CITY OF PORT ST. LUCIE PROJECT#
 COPSL Project No.: P22-180
 PSLUSD File No.: 5336C

Landscape Key Sheet
 Landscape Construction Plans
 Belterra Tradition Phase II
 Port St. Lucie, Florida

REV.	DATE	DESCRIPTION	BY
3	02.07.23	Revision Per City Comments.	nfb
2	10.25.22	Revision Per City Comments.	nfb
1	08.01.22	Revision Per City Comments.	nfb

Dog Park
Landscape Construction Plans
Belterra Tradition Phase II
Port St. Lucie, Florida

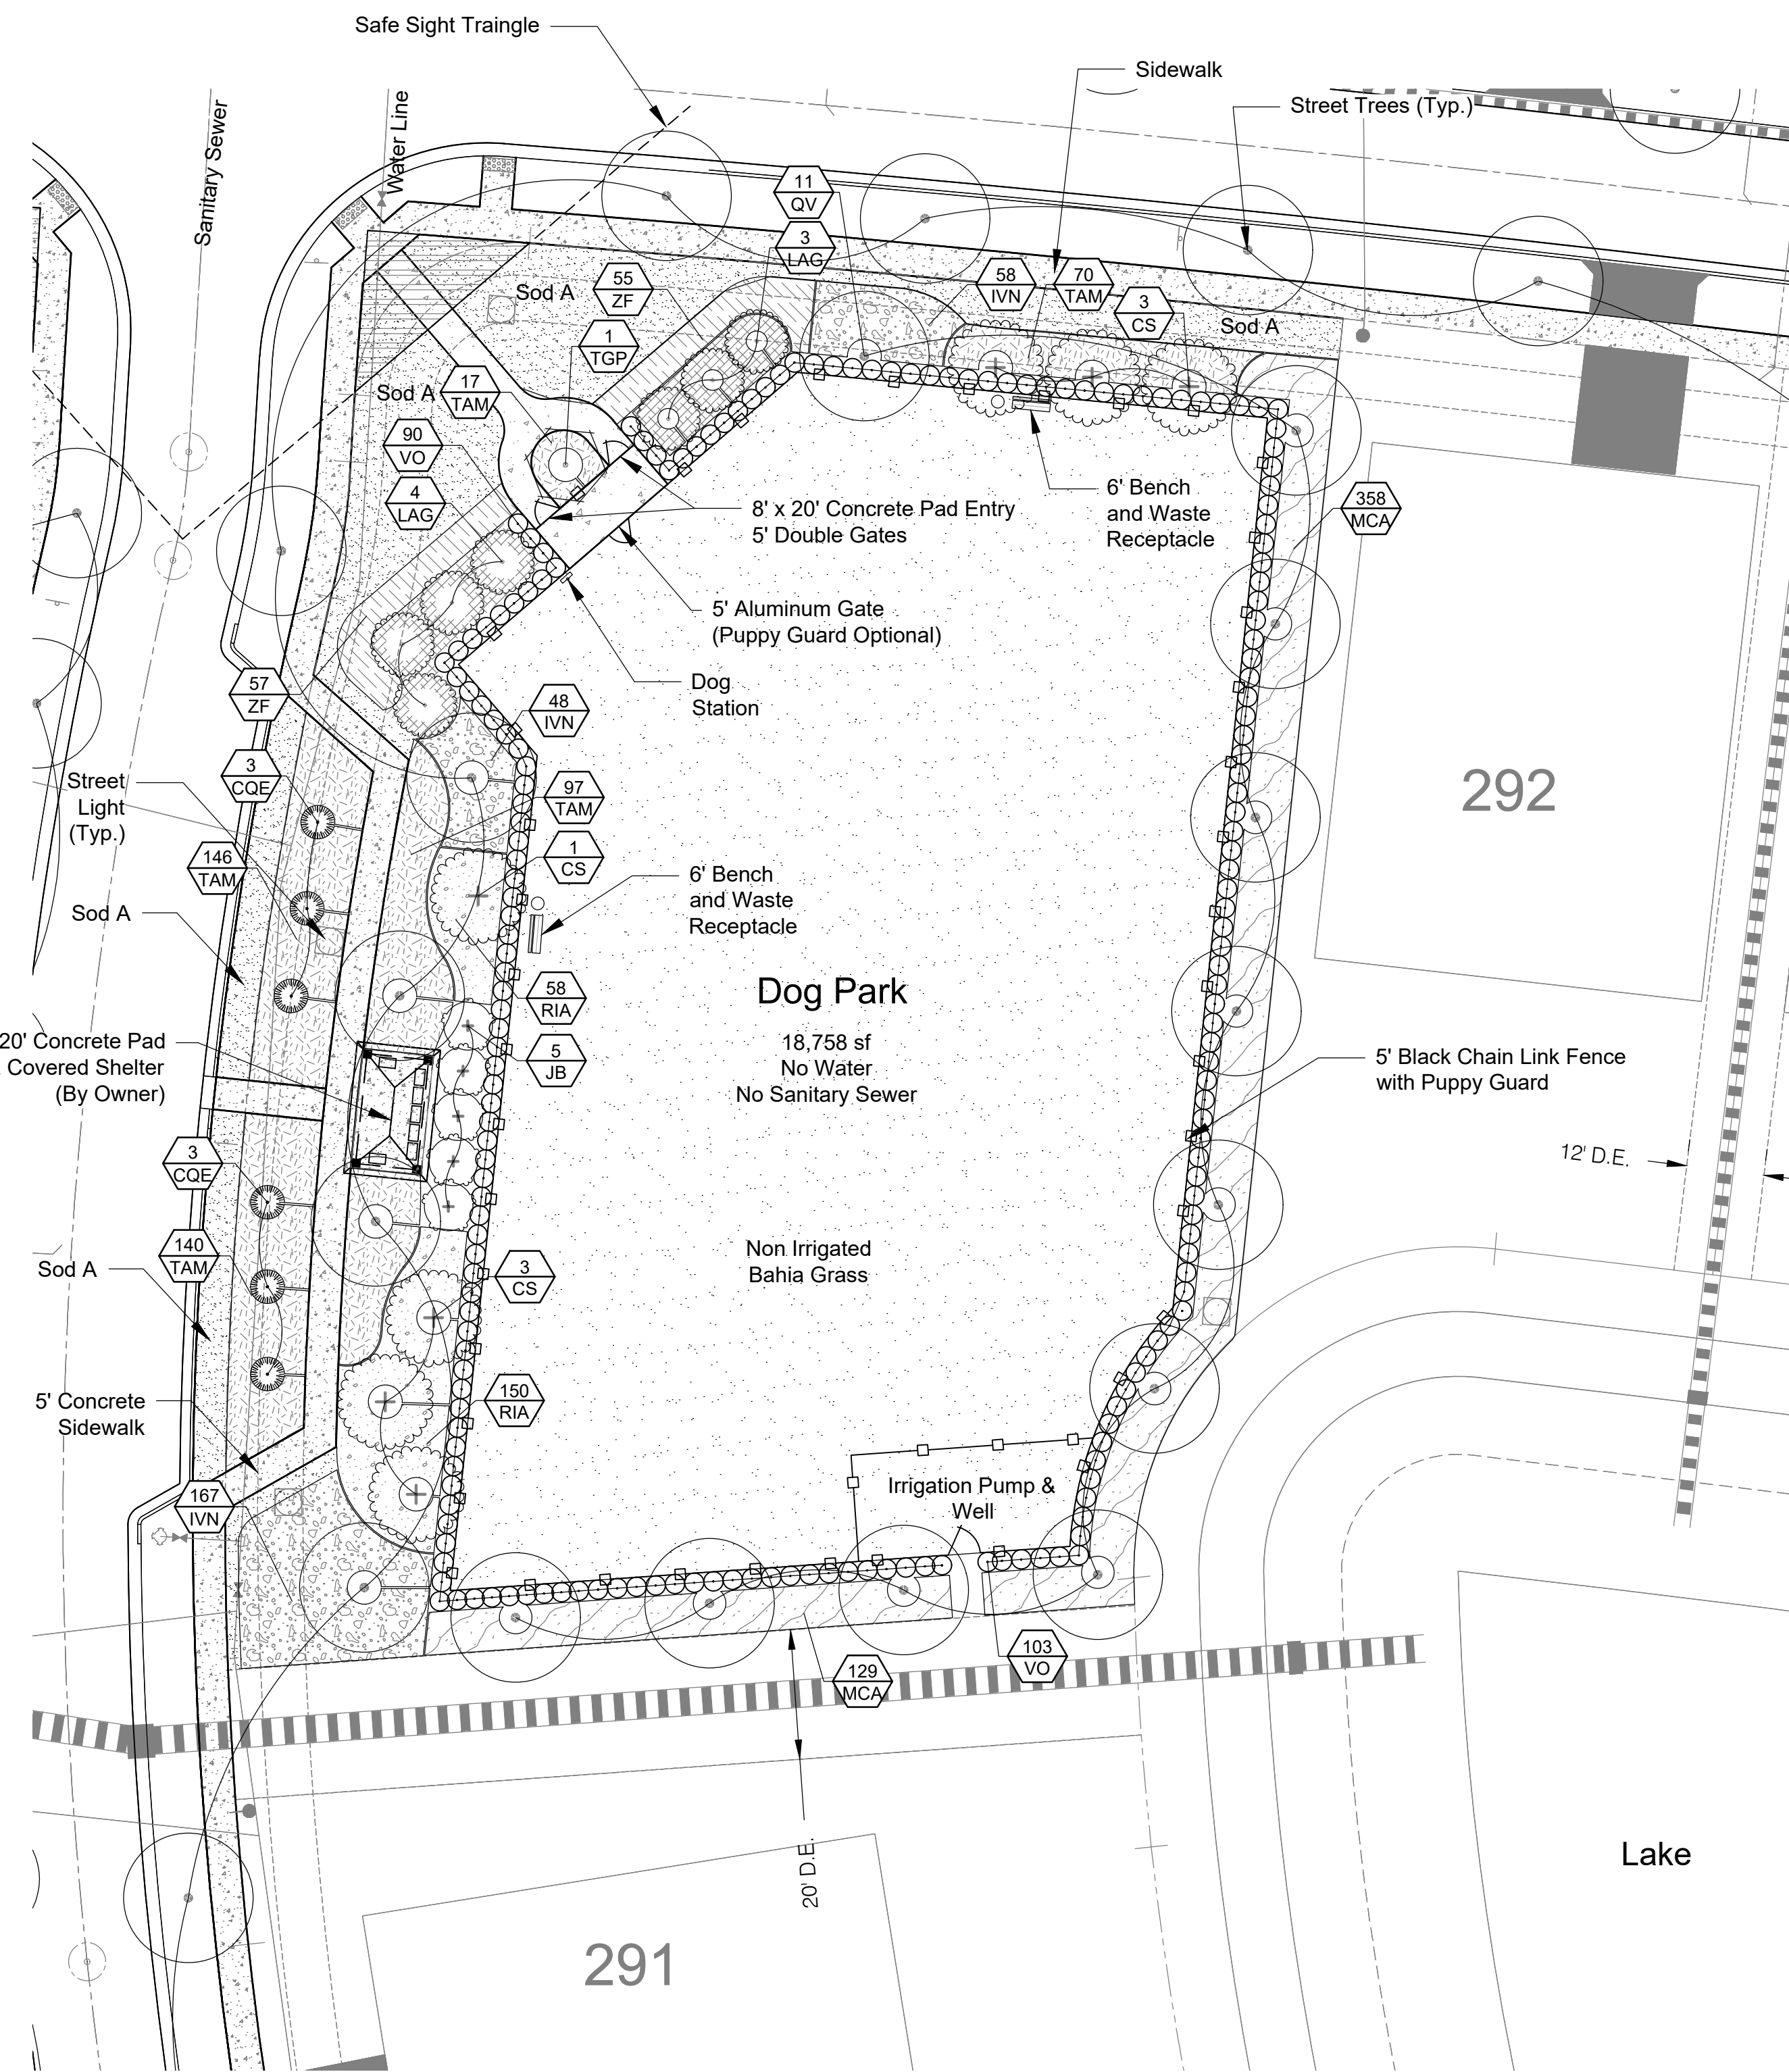
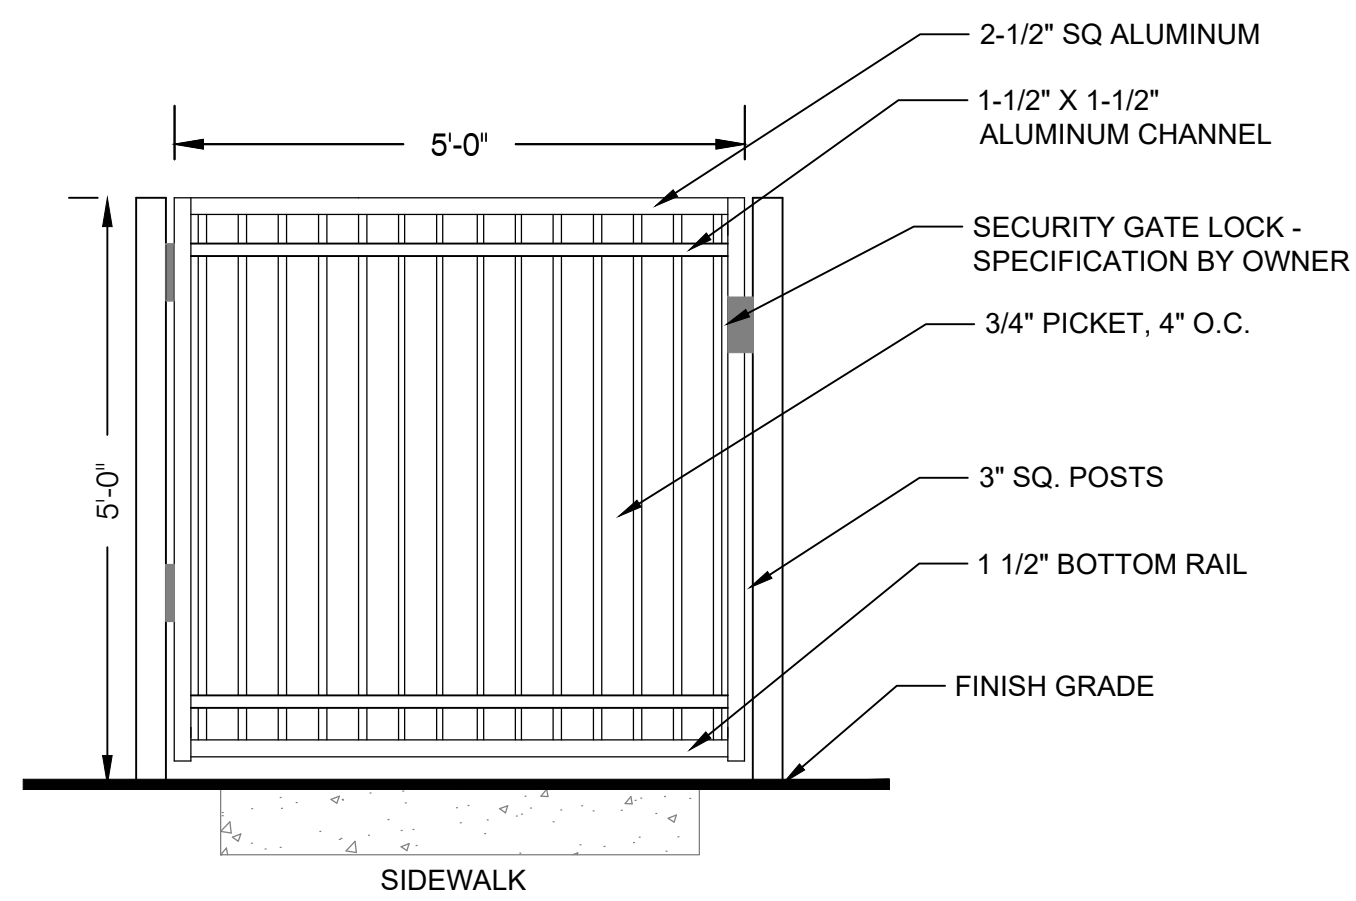
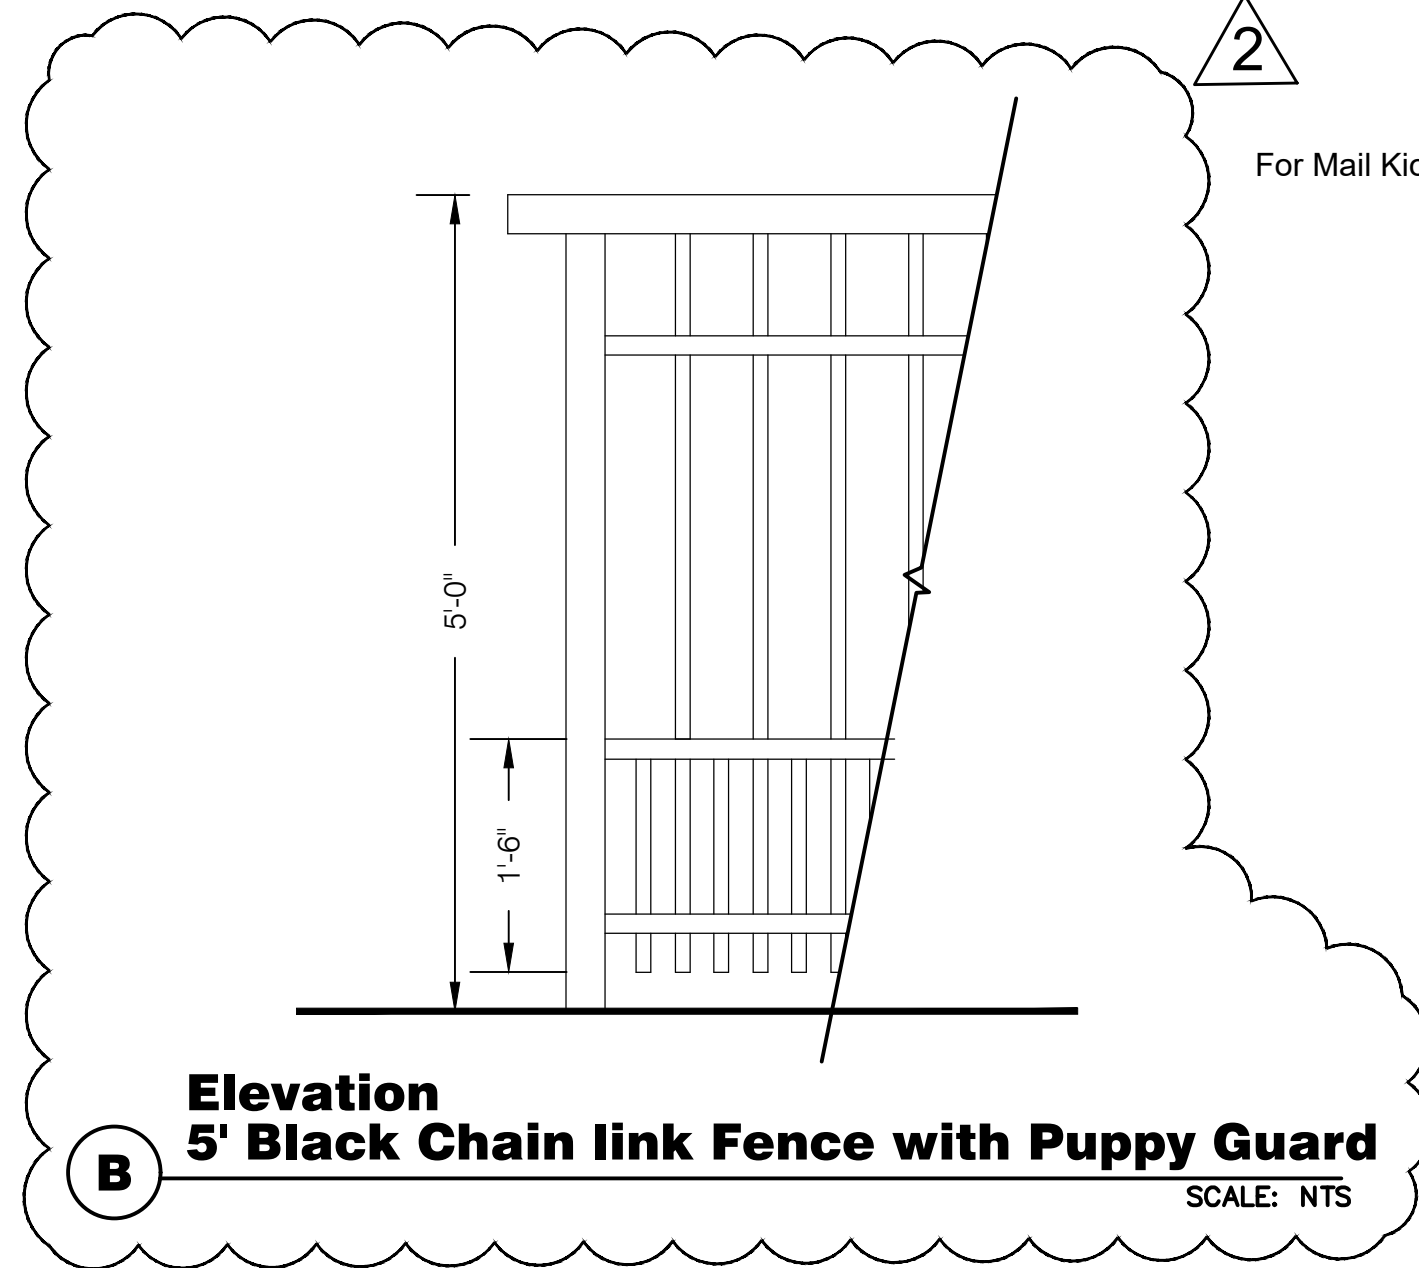
- Mail kiosk & shelter added.
- Dog park reconfigured to accommodate mail kiosk.
- Puppy guard added to gate.
